**Addendum No. 1**

**Subject: J. Hampton Moore School  
Major Renovation Phase 2B – Interior Renovations  
SDP Contracts No. B-083C and B-084C of 2016/17**

**Location: J. Hampton Moore School  
1100 Tyson Avenue  
Philadelphia, PA 19111**

**This Addendum, dated 7th of November, 2017, shall modify and become part of the Contract Documents for the work of this project. Any items not mentioned herein, or affected by, shall be performed strictly in accordance with the original documents.**

DRAWING NO.  
**FA.04**  
J. HAMPTON MOORE SCHOOL

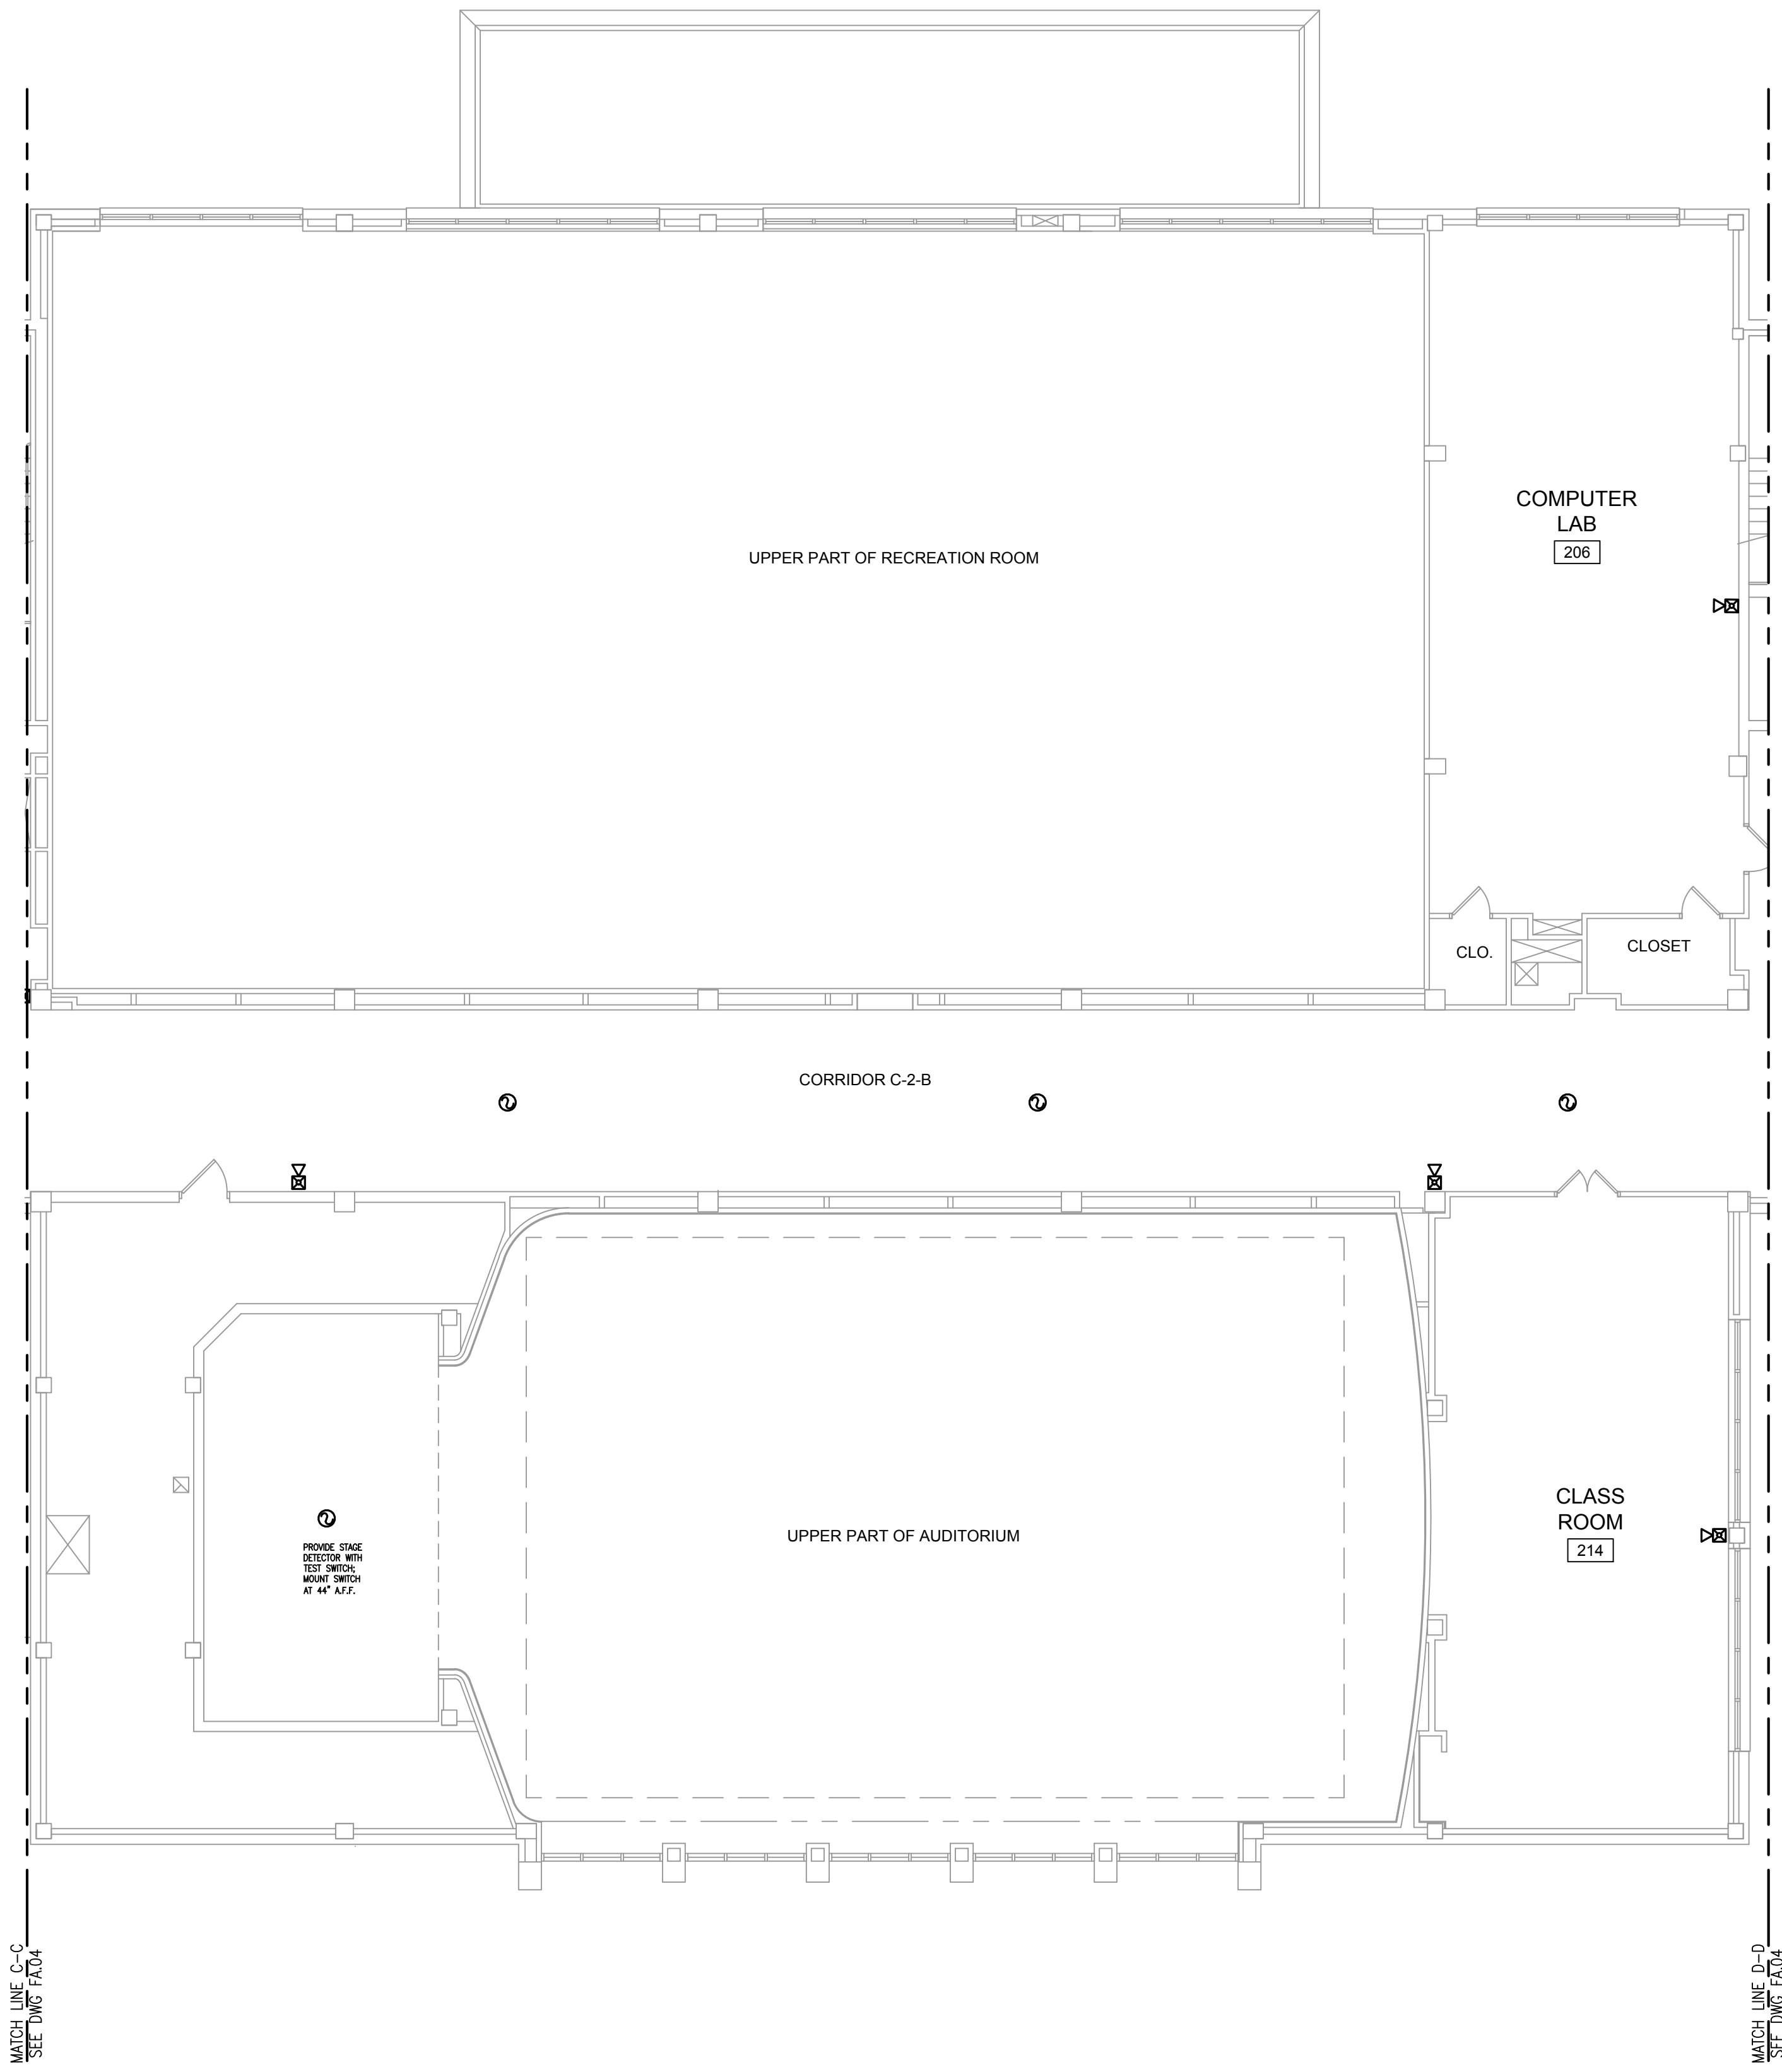
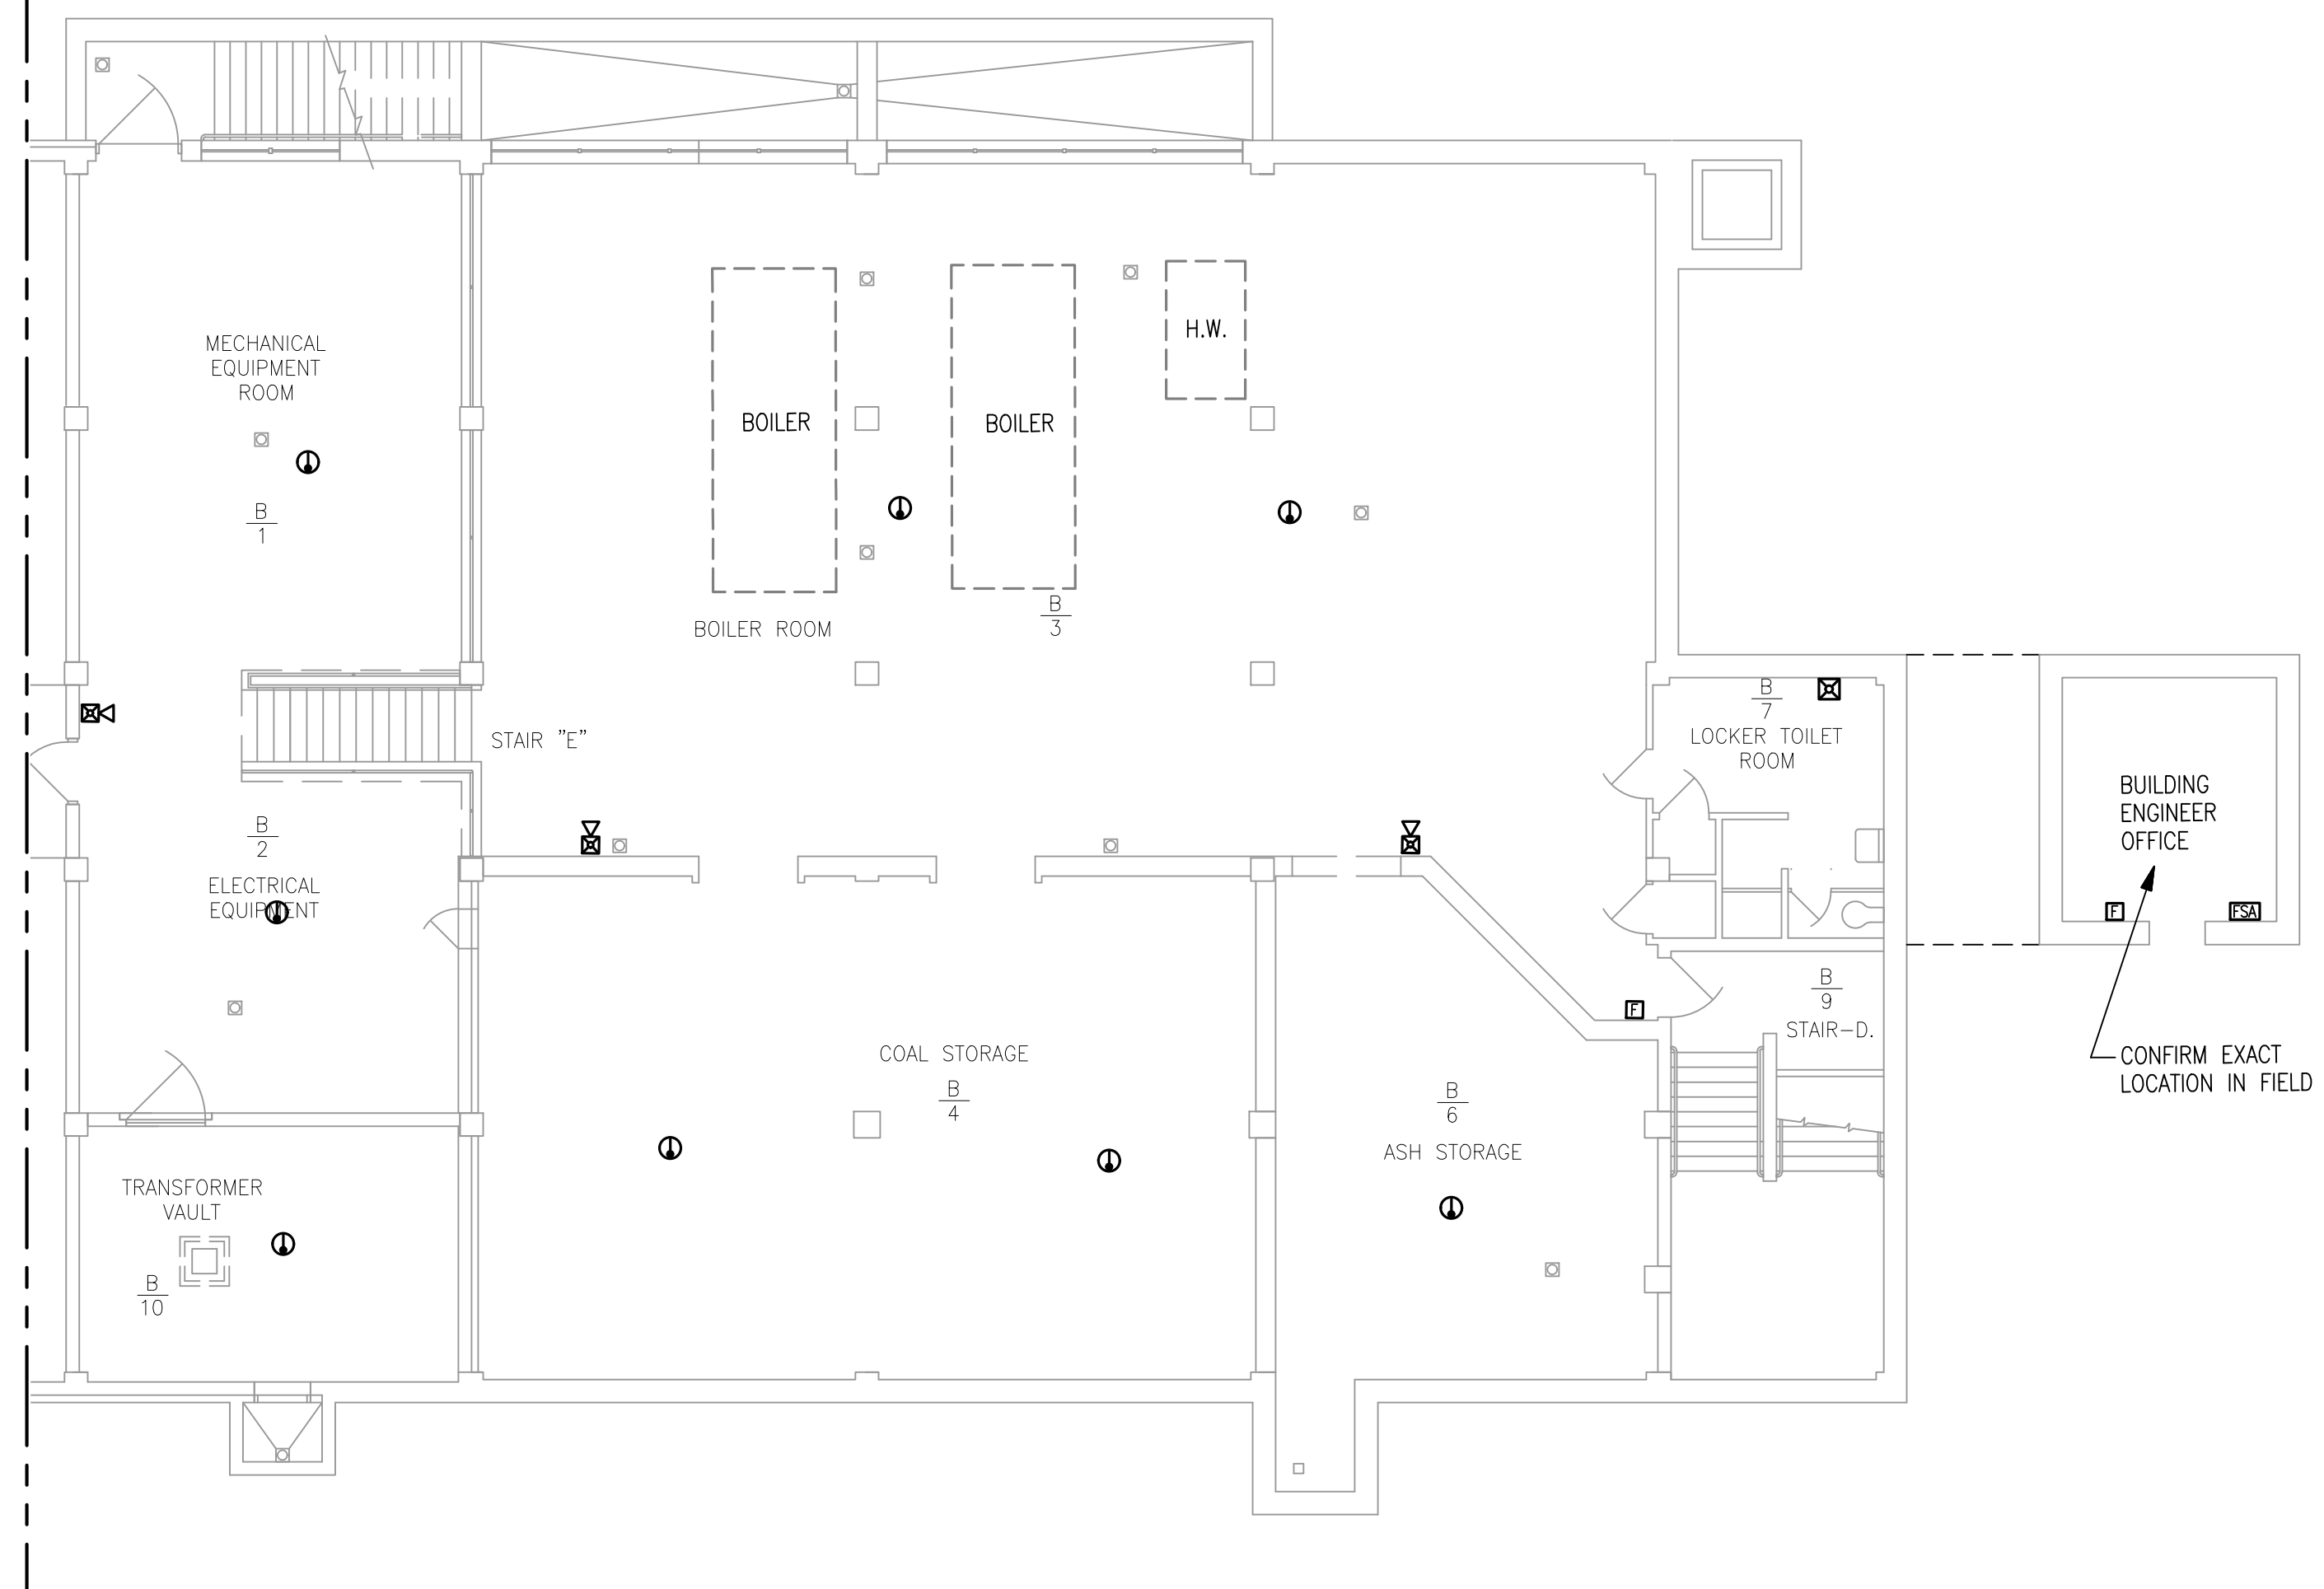
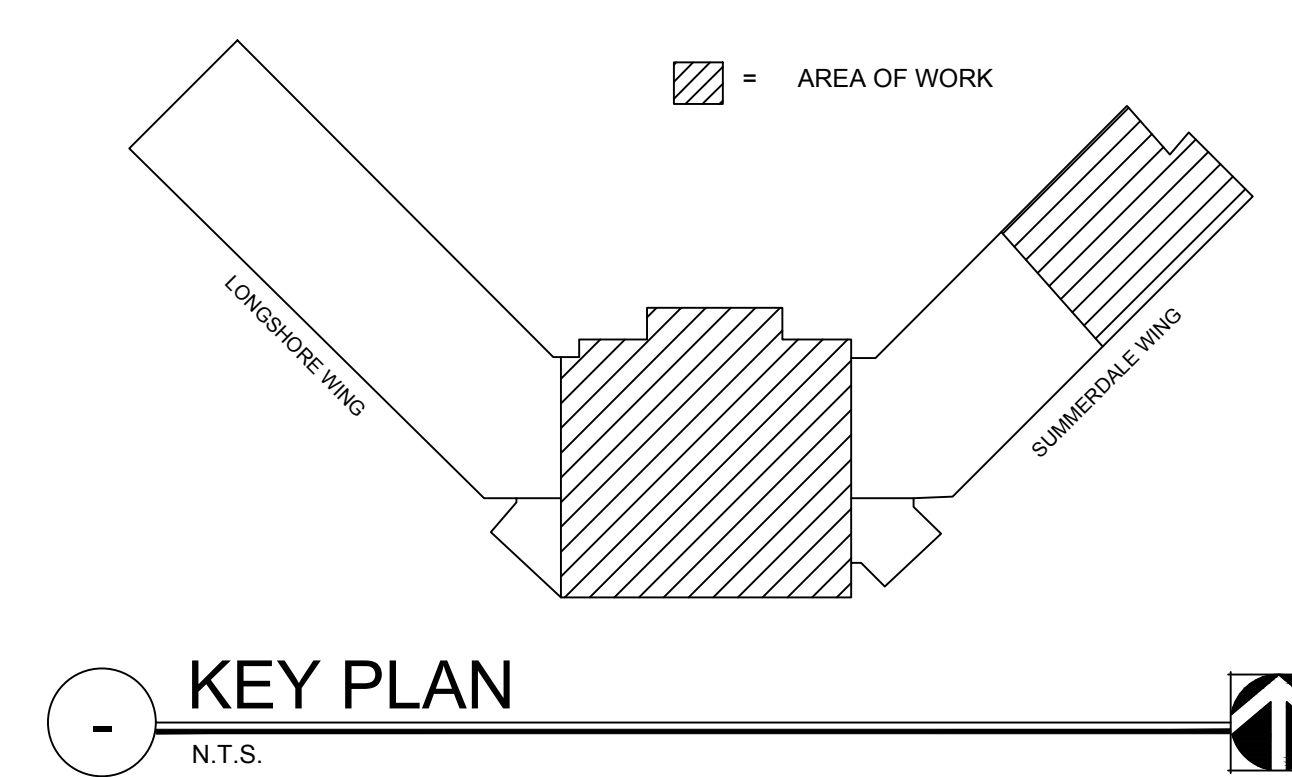
- 1. Drawing E2.02 is revised to include PA speakers and wireless clocks in the new modular building. The modular building is provided by others and is not part of this project.**
- 2. Drawing E5.04 – Detail 3 mounting detail is modified to include power/control cable.**
- 3. Drawing E6.01 – PNL L main rating changed to 225A; PNL L breaker at MDP2 changed to 175A; feeders from MDP2 to PNL L changed to 4 #2/0 & 1-#6 Gnd.**
- 4. Drawings FA.01 thru FA.04 – Notification circuit power booster (NAC) added to symbol legend; Location of NAC have been indicated on plans; Note 4 and 6 have been modified.**

5. APPROVED FIRE ALARM VENDORS ARE EDWARDS, NOTIFIER, SIEMENS, SIMPLEX OR APPROVED EQUAL. PROVIDE 120 VOLT CIRCUIT FOR THE FACP. EACH REMOTE ANNUNCIATOR AND FOR EACH NAC (NOTIFICATION CIRCUIT POWER BOOSTER (120VAC)) FROM THE EMERGENCY PANEL THAT IS BEING PROVIDED IN ANOTHER CONTRACT.

6. PROVIDE 120 VOLT CIRCUIT FOR THE FACP. EACH REMOTE ANNUNCIATOR AND FOR EACH NAC (NOTIFICATION CIRCUIT POWER BOOSTER (120VAC)) FROM THE EMERGENCY PANEL THAT IS BEING PROVIDED IN ANOTHER CONTRACT.
